IN RE APPLICATION OF : Decai (NMI) Sun, et al.
FOR : **A SEMI-TRANSPARENT POWER
MONITOR INTEGRATED WITH A
LIGHT PRODUCING MODULE**
SERIAL NO. : Unknown
FILED : Herewith
EXAMINER : Unknown
GROUP ART UNIT : Unknown
ATTORNEY DOCKET NO. : D/99580I
XER 2 0292-3

PRELIMINARY AMENDMENT

REQUEST FOR AMENDMENT TO DRAWINGS

FIG. 1
PRIOR ART

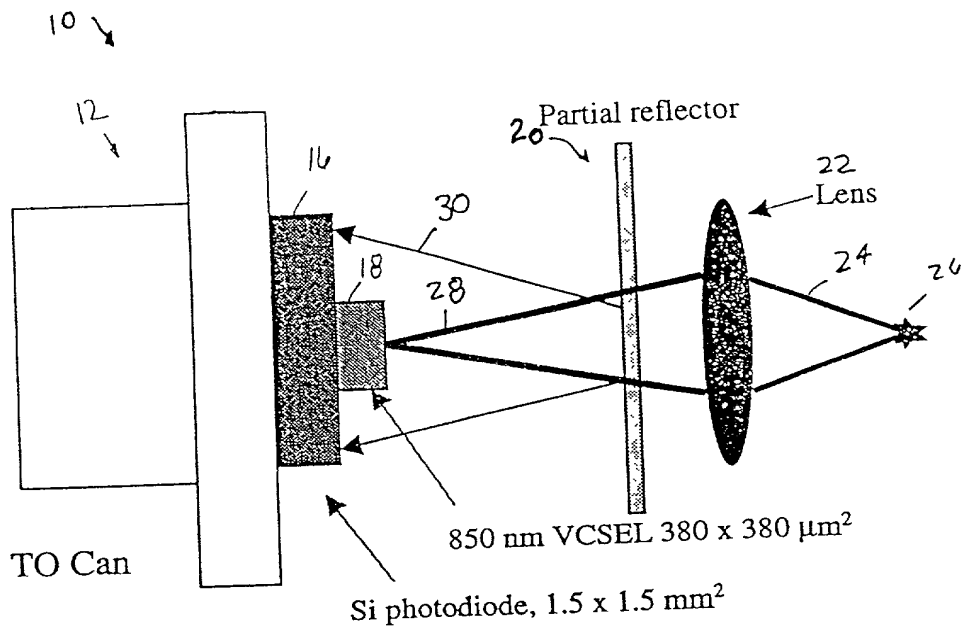
Approval to amend FIGURES 1, 5a, 5b, 5c, 5d, 6a, 6b, 6c, 6d, 7-19, 21a, 21b, 22a, 22b and 25 as illustrated in red in the enclosed drawing copies is respectfully requested.
A duplicate copy of this request is being submitted to the Official Draftsman.

FIG. 4

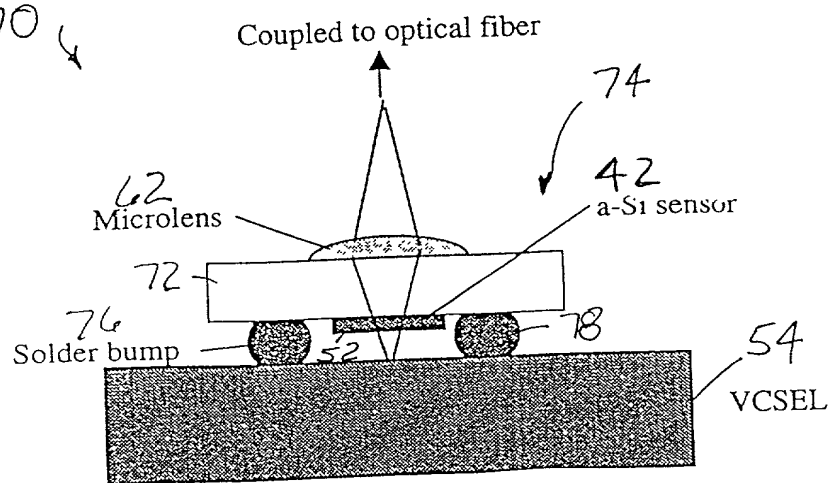
Turning to FIGURE 4, illustrated is an optical transmitter system **70**, where a VCSEL **54** is integrated with substrate **72** having formed thereon semi-transparent silicon sensor **42** and micro-lens **62**. More particularly, system **70** allows for an integrated transmitter to be packaged in a TO Can. In this embodiment, semi-transparent sensor **42** and micro-lens **62** are integrated on quartz substrate **72** as a sensor chip **74**. Thereafter, sensor chip **74** with the built-in sensor and micro lens is attached to the VCSEL **54**. Such interconnection may be accomplished by many connecting schemes including flip-chip bonding using solder bumps **76** and **78**, as well as other discussed techniques. Though not shown, electrical contacts of the amorphous silicon sensor **42** may be passed on to wire bonding pads on the top surface of the VCSEL **54**. These wire bonding pads will be isolated from the VCSEL using a dielectric layer. The entire module is then solder bonded to a heat sink in a TO Can.

Figure 12B

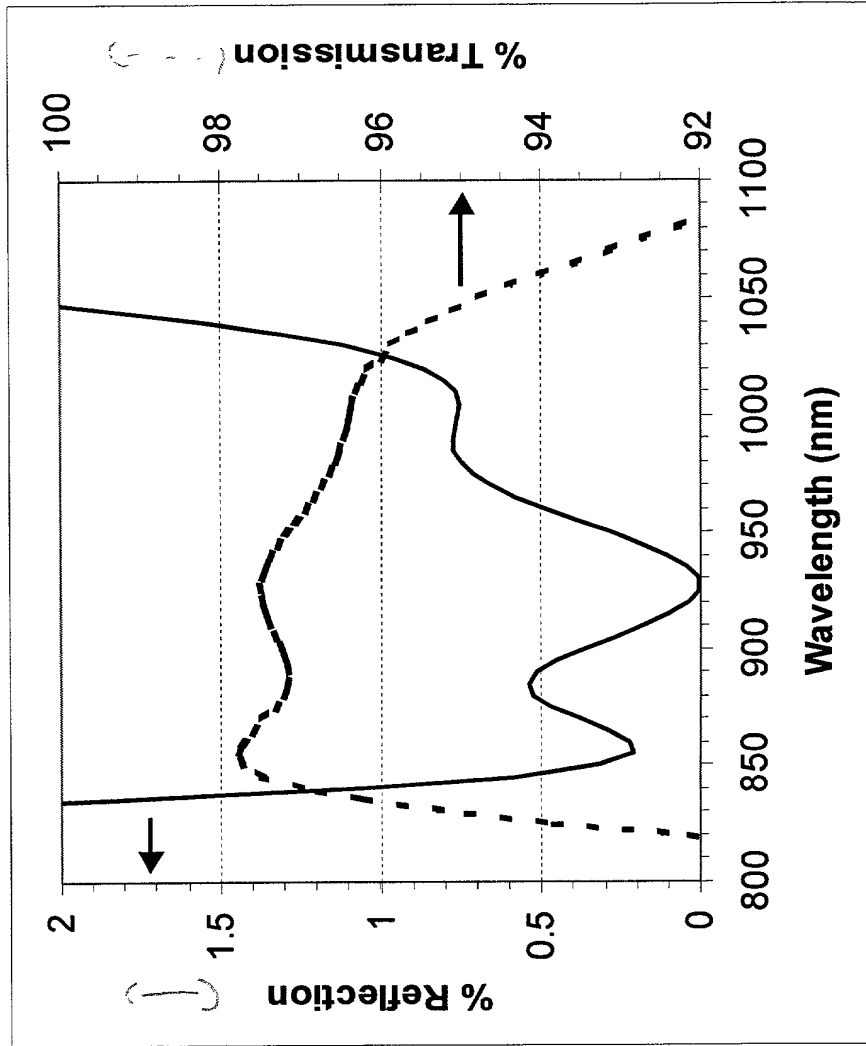
FIGURE 12b is a graphical representation of transmission and reflectance characteristics for a device configured according to the present invention for operation optimized at 850nm;

Turning attention to FIGURES 12a-b, provided is a graph of light transmittance

versus light wavelength (nm) for a device, shown as a block diagram, configured using the above materials in the recited thicknesses. As may be observed in this graphical representation, the highest percentage of light passage is at approximately the 850nm wavelength, where light transmittance reaches nearly 98 percent.

Figure 17B

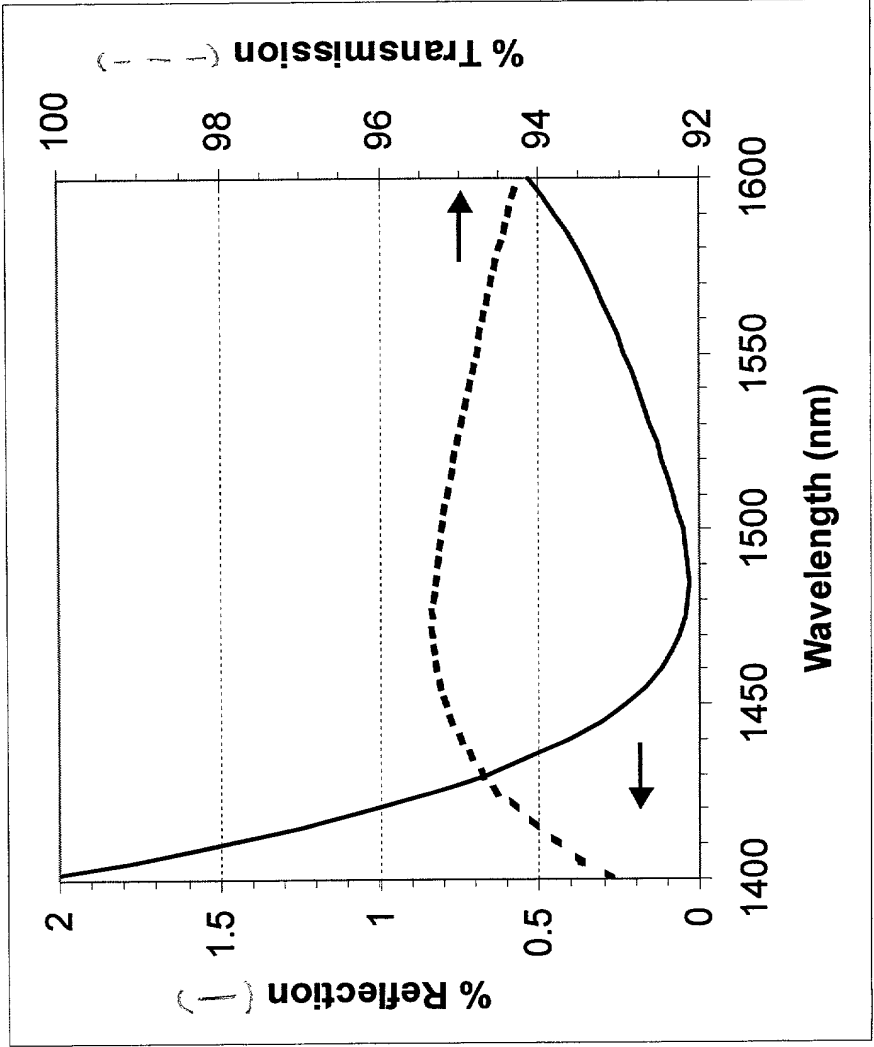
FIGURES 17a-b show a graph of light transmittance versus light wavelength (nm) for a specific design which may be implemented in accordance with the teachings of this application. More specifically, the operational characteristics shown in FIGURE 17b are for a device, as shown in FIGURE 17a, with a layer of silicon having a thickness of approximately 35.48nm deposited on a glass substrate. A SiO₂ layer having a thickness of approximately 86.68 nm is positioned above this silicon layer. A second silicon layer having a thickness of approximately 141.84nm is then placed above the SiO₂ layer. A lower ITO electrode having a thickness of approximately 10 nm is placed next, upon which is positioned an amorphous silicon (Si) sensor region approximately 663 nm thick, followed by an upper ITO electrode having a thickness of approximately 20 nm thick. Above the upper ITO electrode is placed another silicon layer having a thickness of approximately 68.10nm, and a final SiO₂ top layer of approximately 274.59nm thick.

Such a design, as shown by the graph of FIGURE 17b, produces a generally high level of transmittance of approximately 95% of light at the 1500nm wavelength. Unlike more conventional anti-reflection designs, this embodiment features several dielectric layers below the first electrode. The design produces a large transmission window that allows operation at a wide range of wavelengths. This wide transmission bandwidth is especially useful in optical communication applications utilizing wavelength division multiplexing.

Figure 183

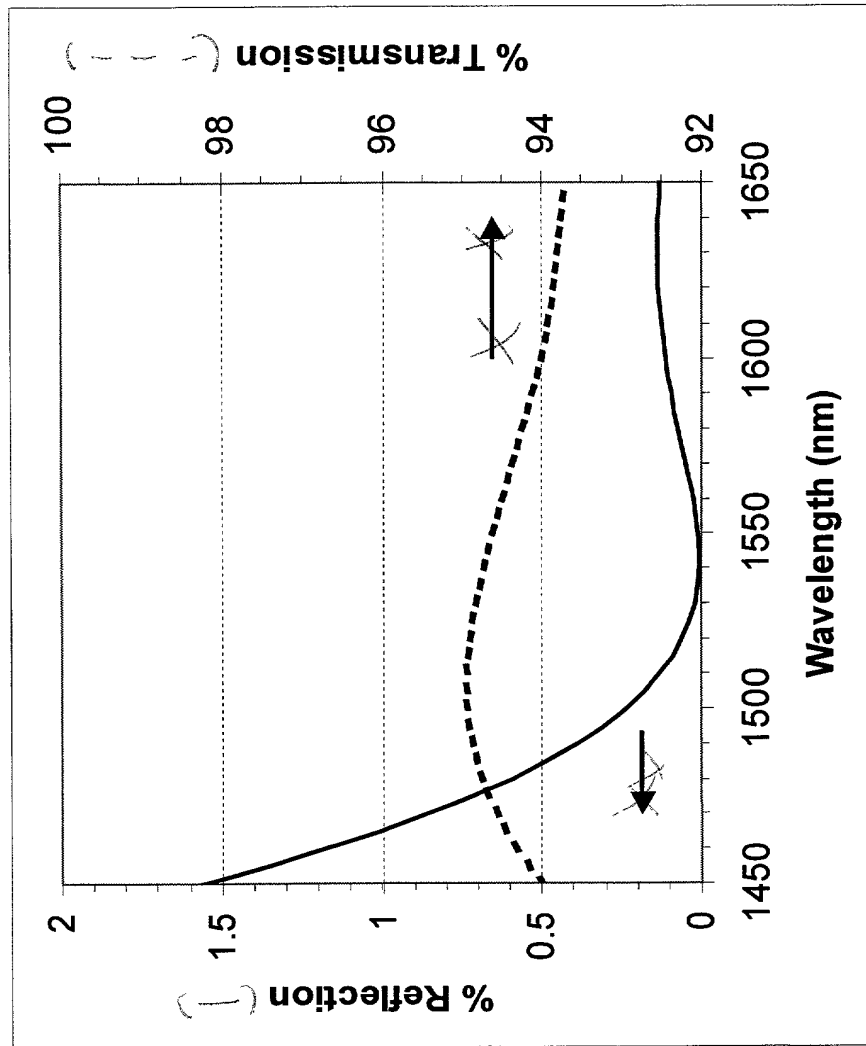
Turning to FIGURES 18a-b, illustrated is a graphical representation for a further device according to the present invention which is intended to have a high transmittance at 1500nm. It is noted that this device, as shown in FIGURE 18a, includes a first TiO₂ layer of 158.13 nm, a first ITO layer of 10nm, upon which is placed a Si layer of 601.47nm. Thereafter, located on top of the silicon layer is a second ITO layer of 20nm, a TiO₂ layer of 102.26nm, and finally a SiO₂ layer of 154.79nm. For this design, the light transmission at 1500 nm wavelength is slightly below 95%.

Comparing the design of FIGURE 17a with the design of FIGURE 18a, it is noted that the design of FIGURE 18a has an advantage of fewer deposition cycles, as the TiO₂ and the SiO₂ may be deposited in the same batch as the ITO. However, when using this design, there is concern with the manner in which the photovoltaic Si layers will grow on the TiO₂.
